BCA & DDA Capability Statement

67 Pacific Parade, Dee Why

26 July, 2024

Reference: S240116

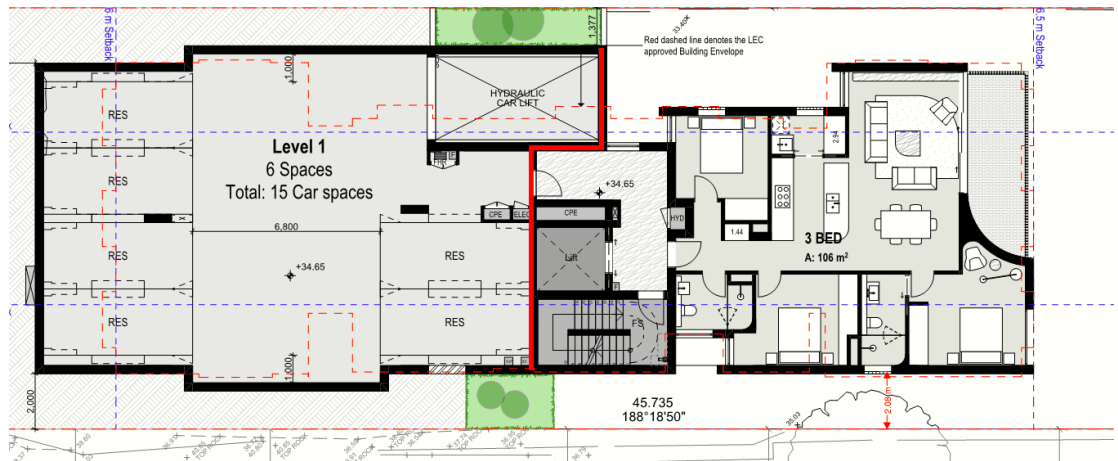
Separation of Classifications: Separate classifications will either need to be separated by a fire wall achieving the higher FRL requirement between the two classes, or alternatively the higher FRL must apply to both areas subject to Spec 5.

Comment: Noted and the design is to ensure that compliance is illustrated.

The higher FRL is required to be applied to provide adequate separation between the Class 2 and 7a parts located on Ground Floor and Level 1, i.e. 120/120/120 FRL to the wall and a -/120/30 fire door as per the image below.

Also, the floor slab that separates the carpark from the Class 2 building part above is to achieve an FRL of 120/120/120.

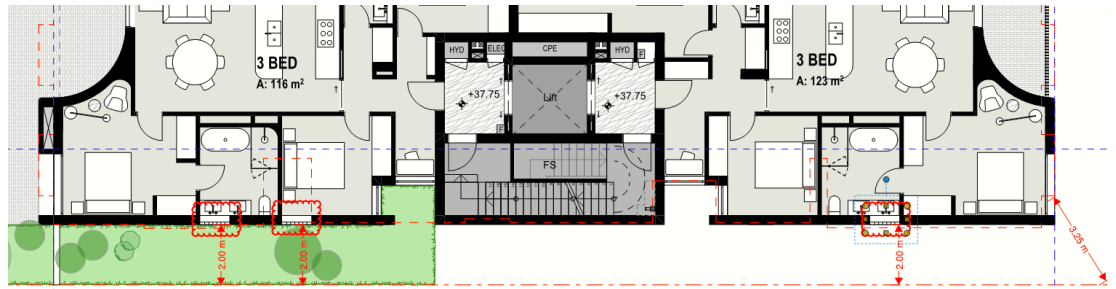
Public Corridors in Class 2 Buildings: Public corridors must not exceed 40m in length, or otherwise be divided at 40m intervals with smokeproof construction.

Comment: Complies.

Corridors within the Class 2 parts do not exceed 40m in length, and therefore no further action is required for smoke separation.

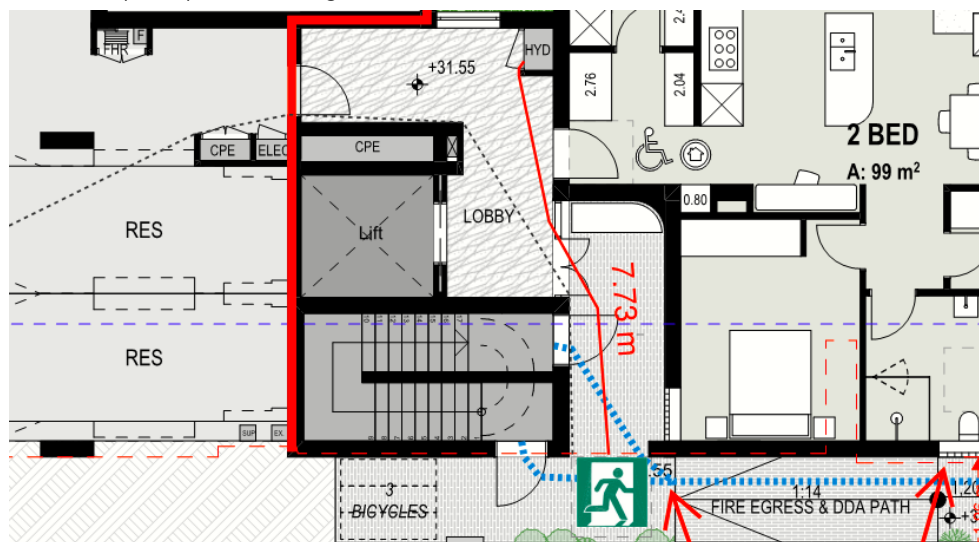
Access for People with a Disability: The extent of access required depends on the classification of the building. Buildings and parts of buildings must be accessible as set out in Clause D4D2 unless exempted by Clause D4D5. The building is required to comply with AS1428.1-2009.

Comment: Refer to section 2.8 of this report for BM+Gs assessment of the building against the Disability Access to Premises standard, Part D4 and AS1428.1-2009.

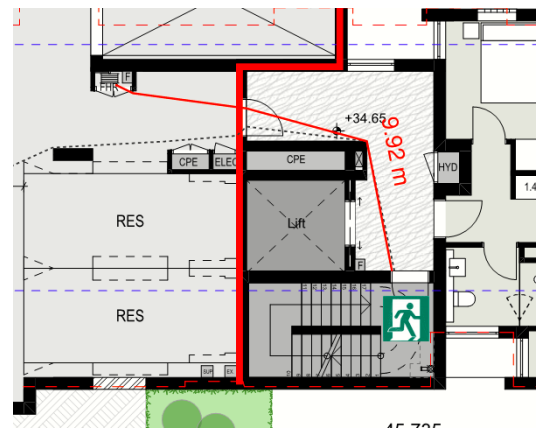
Fire Hose Reels: Fire hose reel coverage is required to be provided to the basement car park levels only. Where required to be provided, fire hose reels are to comply with AS 2441 – 2005. Design consultant to confirm compliance at the Construction Certificate stage.

Comment: It is noted that fire hose reel coverage in accordance with AS2441-2005 is provided to the Class 7a carpark.

Performance Solution: A performance solution is required to address the fire hose reels on the ground floor and level 1 to be located greater than 4m from an exit.
